City of Alexandria, Virginia

MEMORANDUM

SUBJECT: CONCEPT REVIEW OF 806 NORTH COLUMBUS STREET
BAR CASE # 2025-00373

The applicant is requesting BAR Concept Review for the development of the vacant property at 806 North Columbus Street into three townhouses.

Figure 1: Comparison of previous and proposed configuration of southern townhouse

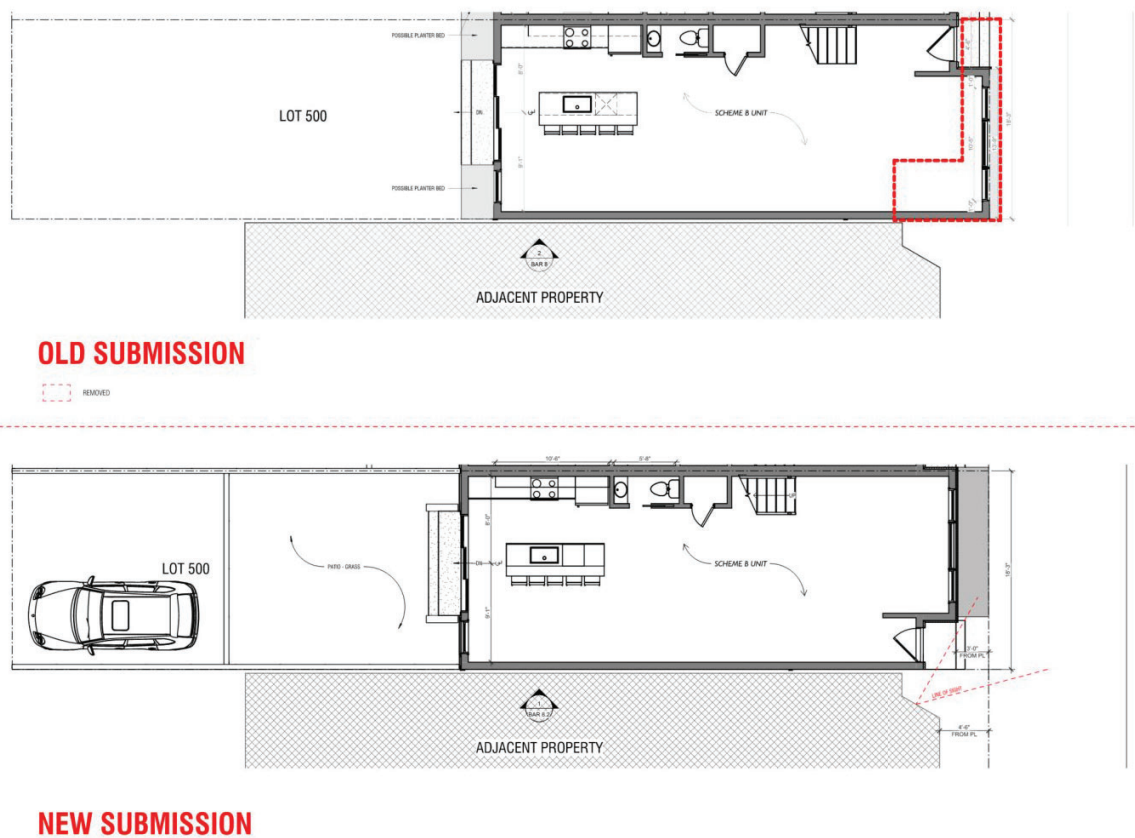
In the previous submission the front of the proposed townhouses was located at the east property line, aligned with the back edge of the sidewalk. During the Concept Review, there was a discussion regarding how the proposed townhouse would affect the existing structure to the south of the project site. This building is located approximately 4'-0" from the east property line and features a three sided bay on the northern section of the east elevation. The proposed townhouses include a rectangular bay with a recessed entry door. In the previous submission, the southern townhouse was situated with the bay on the south side and the recessed entry on the north side. Combined with the location of the building in front of the existing structure to the south, there was concern that this configuration overwhelmed the bay on the existing building.

In the revised submission, the applicant has made two revisions to address this concern regarding the relationship of the proposed townhouses to the existing building to the south (Figure 1). First, the townhouses have been moved back from the east property line by 3'-0". This places it approximately 1'-0" in front of the existing building instead of the previous 4'-0". Second, the proposed southern townhouse has been mirrored to place the bay on the north side of the lot and the recessed entry on the south side, adjacent to the bay on the existing building to the south of the site. The effect of this is that the front wall of the new townhouse immediately adjacent to the south property line is behind the front of the bay on the existing townhouse. This opens up the view of the existing three sided bay from the street and reduces the overall impact of the proposed townhouses on the existing historic building.

FRONT ELEVATION
COMPARISON

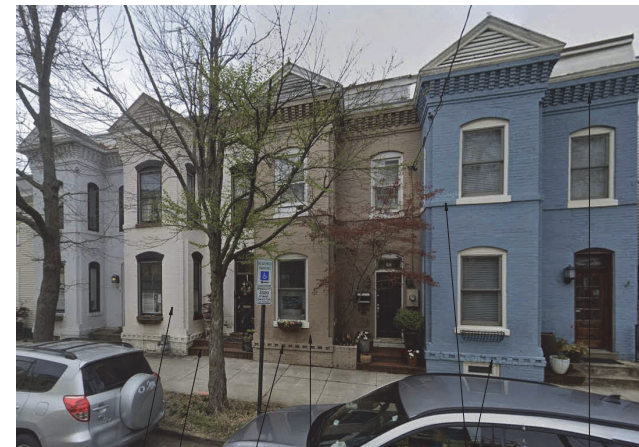
BRICK FACADE — BRICK DETAILS — REPEATING ELEMENTS — DETAILED CORNICE —
FRONT STEPS — HISTOCAL BAY —

1. THE BAY IN LOT 500 WAS FLIPPED TO ACCOMMODATE NEIGHBORING PROPERTY'S SUGGESTIONS, IT NOW PROVIDES MORE NATURAL LIGHT.
2. THE OVERALL HEIGHT OF THE BUILDING WAS REDUCED TO 42'-6".
3. THE ROOF DECK / 4TH FLOOR WAS INSET 3 FT TO REDUCE MASSING.
4. THE ROOF DECK / PARAPET WALL IS NOW SET 3' BACK, AWAY FROM THE BAY TO REDUCE MASSING.

**NORTH ELEVATION
COMPARISON**

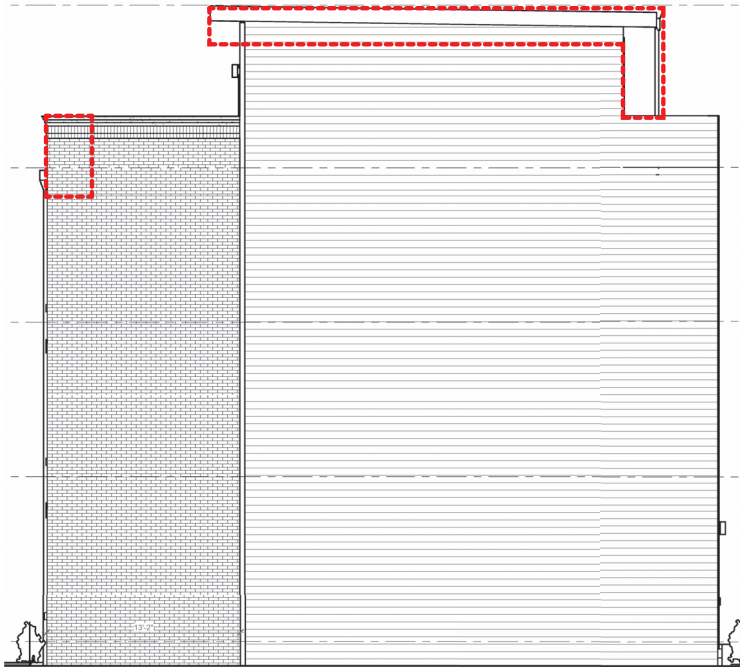
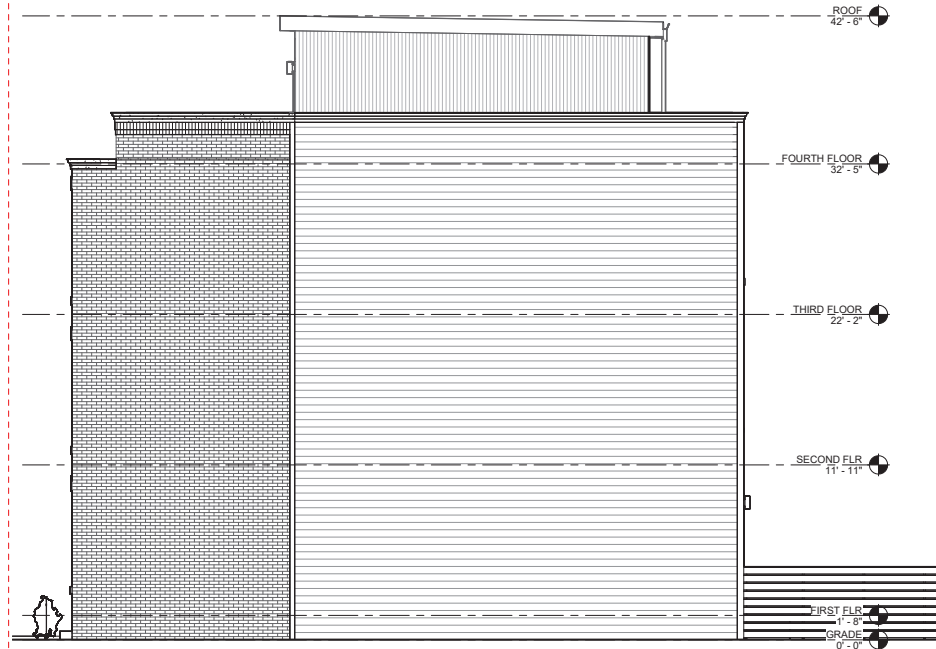
As noted during the Concept Review discussion, the visibility of the fourth floor enclosure is limited when viewed from the front because of the step back from the front elevation but when viewed from the north or south, this enclosure was highly visible. To address this concern, the revised design includes a 3'-8" step back for the fourth floor from the north and south edge of the building. The effect of this will be to limit the visibility of this part of the structure and to make it read as a secondary roof structure instead of part of the main block of the building.

1. HORIZONTAL WOOD PLANK FENCE WILL PROVIDE THE REAR WITH MORE PRIVACY.
2. THE OVERALL BUILDING HEIGHT WAS REDUCED 2'-6", ADDRESSING THE MASSING COMMENTS.
3. THE ROOF DECK / GUARDRAIL IS NOW SET 3' BACK, AWAY FROM THE BAY AND ADJACENT PROPERTIES TO REDUCE MASSING.

SHEET NAME
PLAN VIEW -
COMPARISON

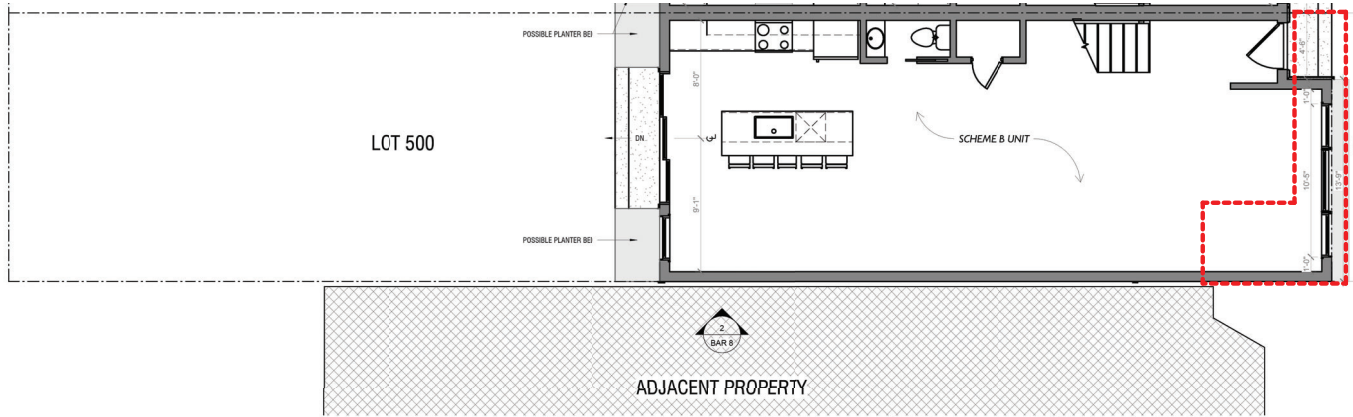
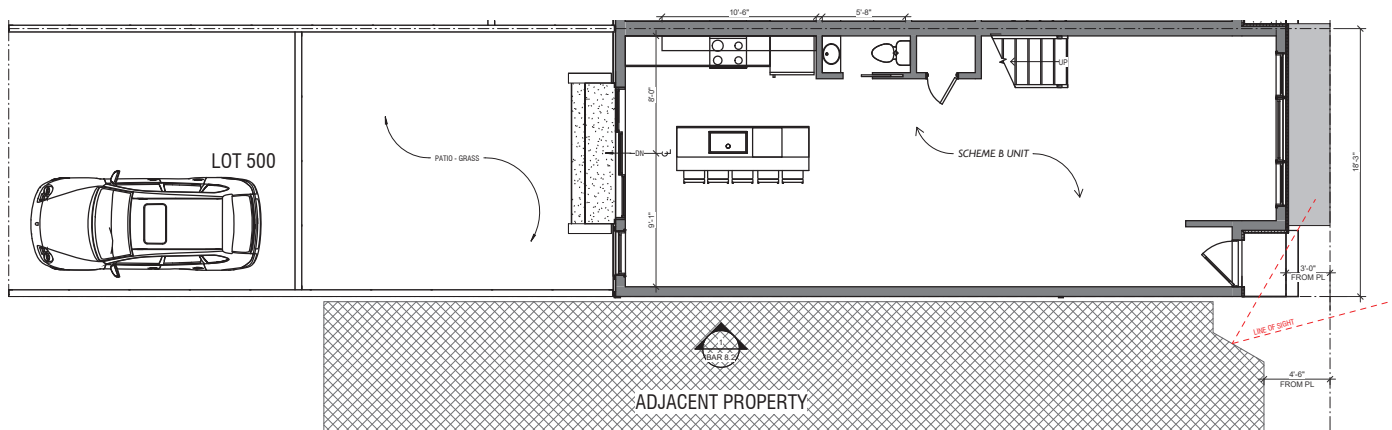
The last submission did not contain much detail regarding the enclosure of the rear yards and how the parking areas are to be configured. Questions about this came up from members of the public and the Board. To address these questions the applicant is now showing a site plan and rear elevation of the proposed townhouses that depict the horizontal wood fence that will be enclosing the rear yards (Figure 3).

1. THE BAY IN LOT 500 WAS MIRRORED TO ACCOMMODATE NEIGHBORING PROPERTY'S SUGGESTIONS. IT NOW PROVIDES MORE NATURAL LIGHT.
2. FENCE IN PARKING/PATIO.
3. THE ENTIRE BUILDING WAS INSET 3 FT FROM PROPERTY LINE.
4. THE ROOF DECK / GUARDRAIL IS NOW SET 3' BACK, AWAY FROM THE BAY TO REDUCE MASSING.
